**City of Richmond**  
Urban Development Division

## Report to Development Permit Panel

**To:** Development Permit Panel  
**From:** Joe Erceg  
Manager, Development Applications  
**Date:** March 18, 2003  
**File:** DP 02-220699  
**Re:** **Application by Onni Development Capital Corporation for a Development Permit at 12333 English Avenue**

A100

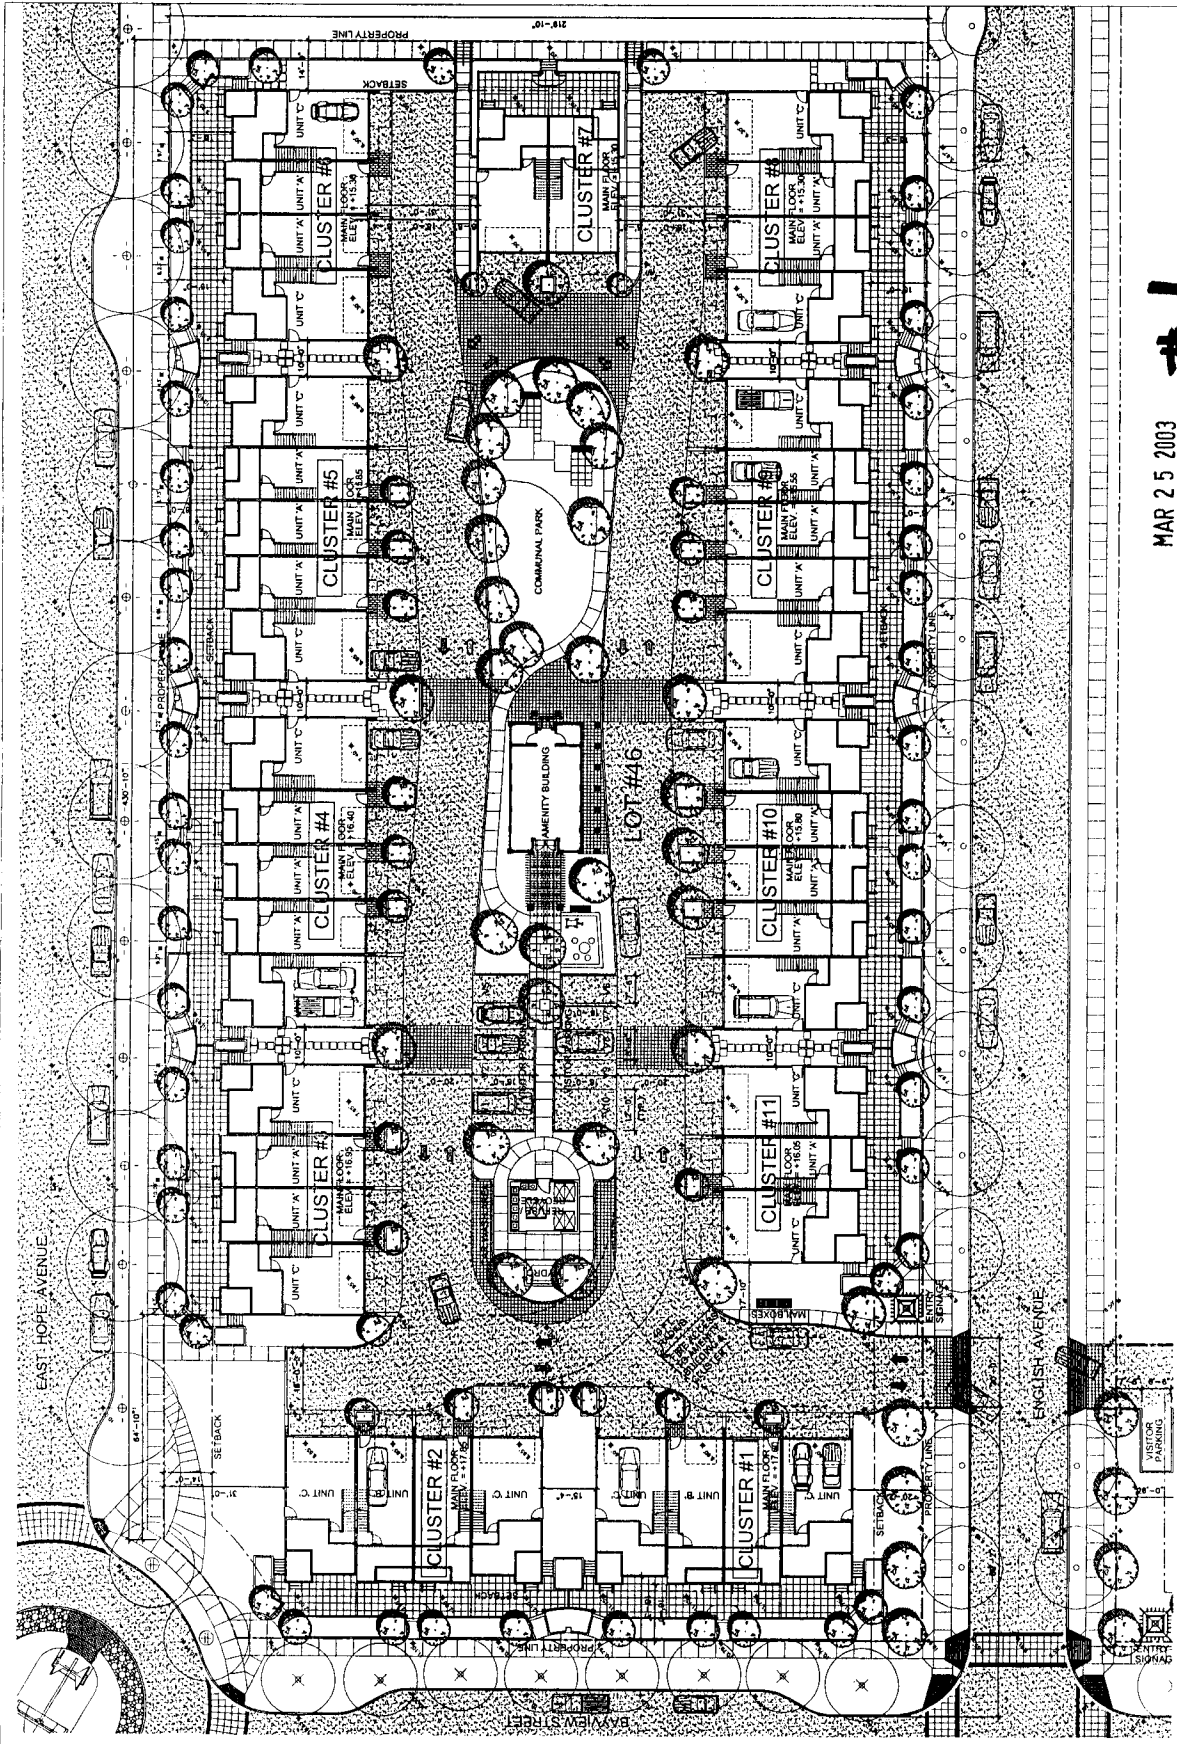
1. Update the Context Plan on drawing A100 entitled 'Title Page & Site Statistics', dated December 24, 2002.
  - a) Reference the following recently approved Development Permits on the Context Plan:

- b) Update the 'Steveston Academy' site planning information.
  - c) Include the preliminary design intent (i.e. anticipated building footprints and massing) for Lots 27, 28, 29 and 30 to the west.

- d) Ensure that the Context Plan clearly differentiates between, recently approved, currently proposed and future development sites within the overall Imperial Landing development. ***The applicant has provided the above information with the final submission. See the revised Context Plan.***

CLUSTER #7  
 DEN FLOOR PLAN  
 SCALE: 1/8"=1'-0"

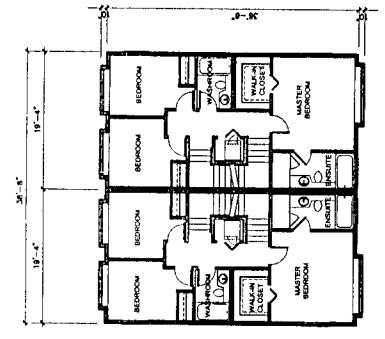
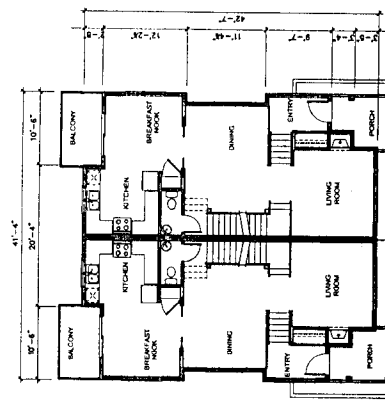
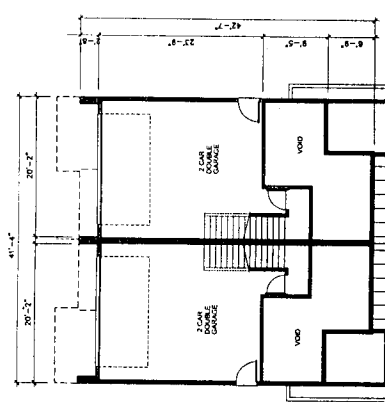
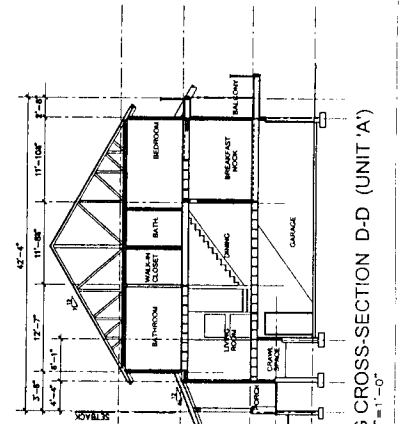
- f) Design a narrower unit plan for building cluster 7 that is based on tandem parking and a three-storey floor plan. ***A narrower, three-storeys unit plan with tandem parking has replaced building cluster 7. See the revised architectural drawings.***

CLUSTER #2, 3, 6, & 8  
 FRONT ELEVATION  
 SCALE: 1/8"=1'-0"

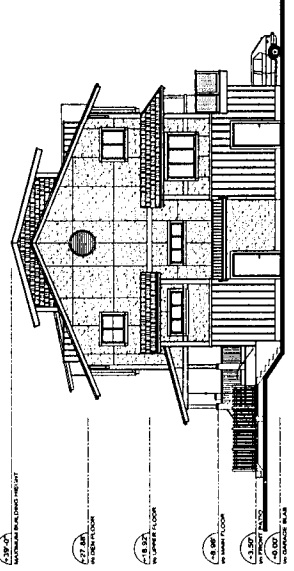
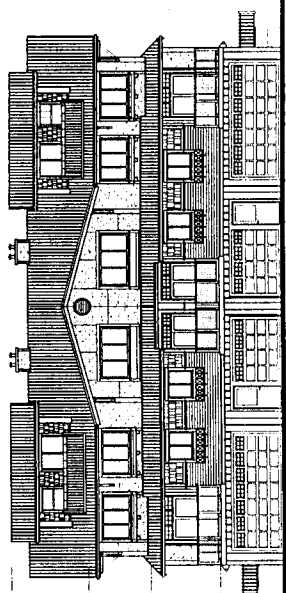
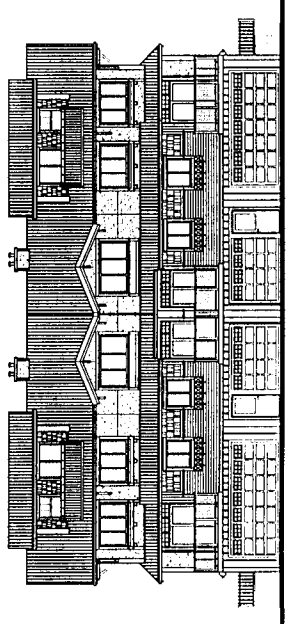
4. The mansard roof form of building clusters 2, 3, 6 and 8 appears foreign. Consider referencing the typical roof design of the former cannery structures with large shed roofs. The proposed flat roof is not supported. The applicant is requested to consider a simplified, large shed or pitched roof form with a variety of dormers (i.e. maintain the roof height but reduce the roof pitch) rather than a mansard roof. The large gable ends of a pitched roof will also create an opportunity to add further interest to the building façades. The metal roof material is supported however; staff prefers a standing-seam versus ribbed or folded metal roof. ***The mansard roof forms have been eliminated from all proposed building designs. All flat roofs have been replaced with large shed roof forms. A high profile ribbed metal roof material is to be used. Please refer to the revised drawings.***

PROJECT: LANDSCAPE ARCHITECTURE  
 CLIENT: DEVELOPER  
 PROJECT NUMBER: 2206 99  
 SCALE: 1/4" = 1'-0"  
 SHEET NUMBER: A501

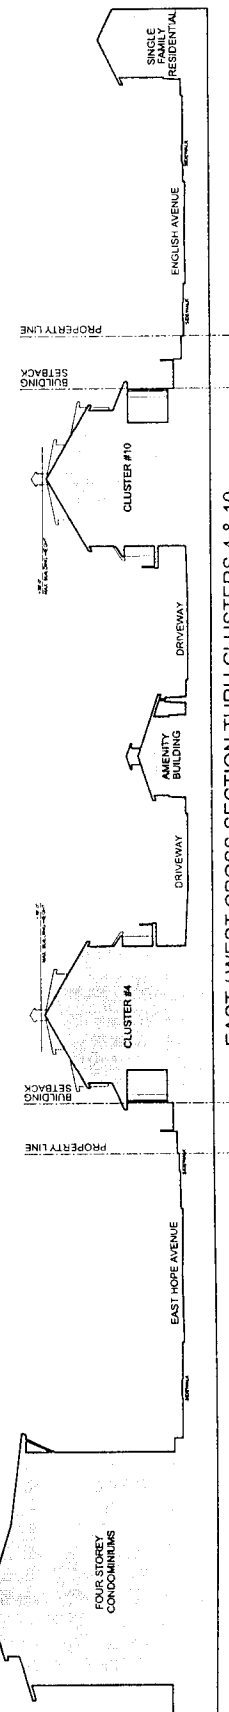
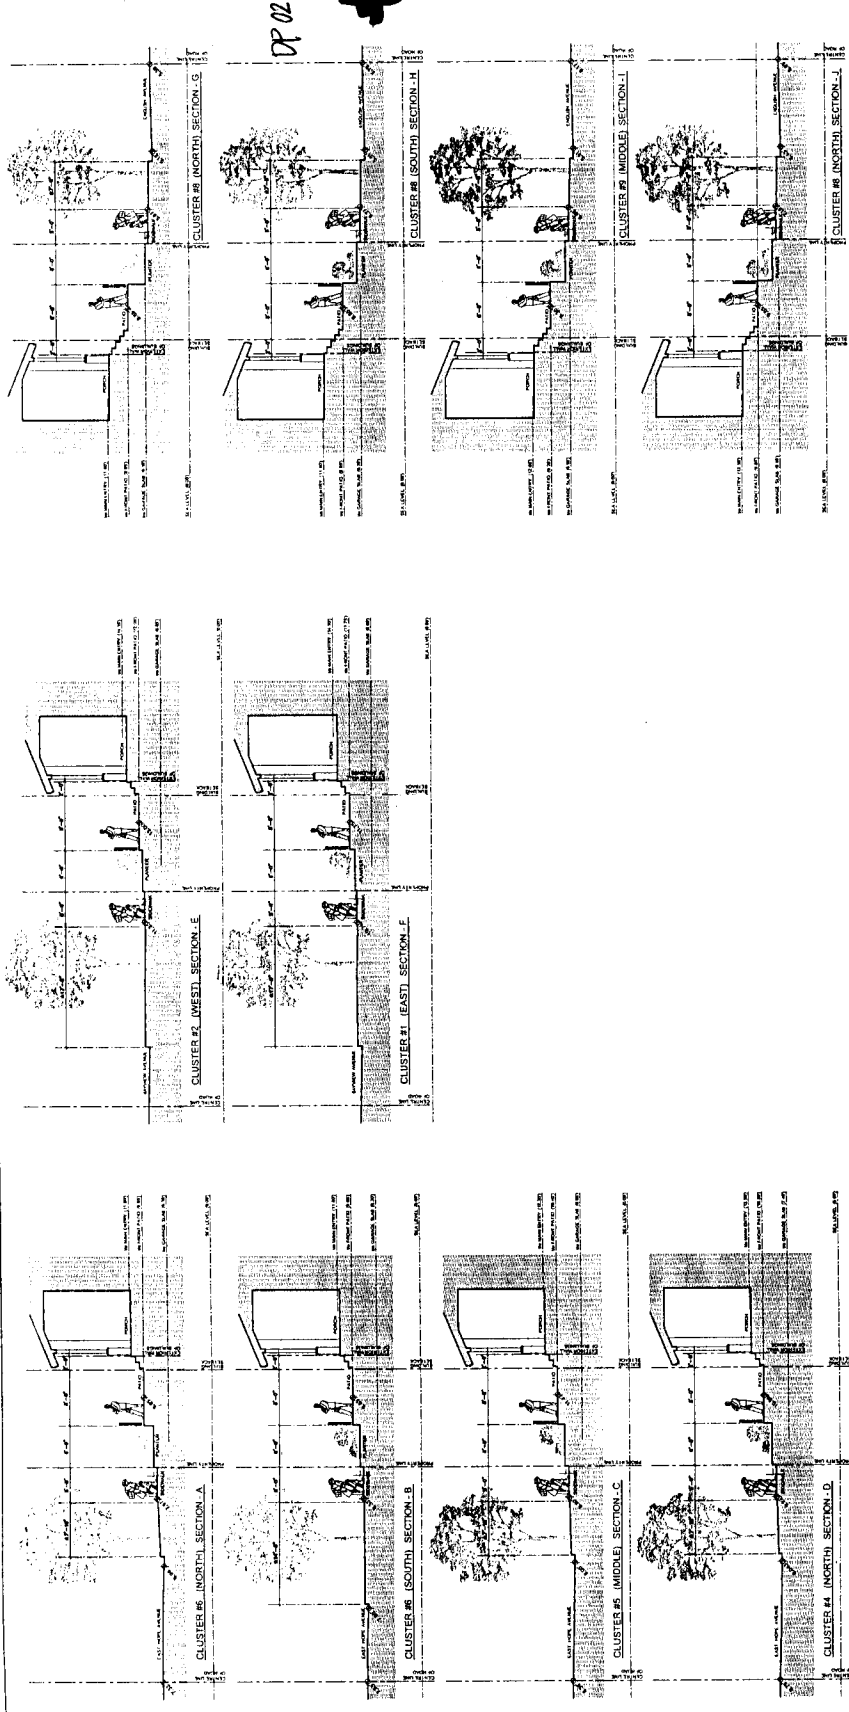
- b) Step the elevation of the private outdoor amenity spaces to terrace down toward the north in order to more closely follow the slope of the street. ***The proposed site grading has been revised to lower the patio levels to terrace down towards the north following the slope of the street. The applicant has lowered the elevation of private outdoor patio areas in the front yards to a maximum height of 0.99 m (3.24 ft.) above the adjacent boulevards. The landscape screening and buffer strip along Bayview Street, English and Easthope Avenues has been increased from 0.61 m (2 ft.) to 1.829 m (6 ft.). See drawing A501 for detailed information on front yard patios and setbacks.***
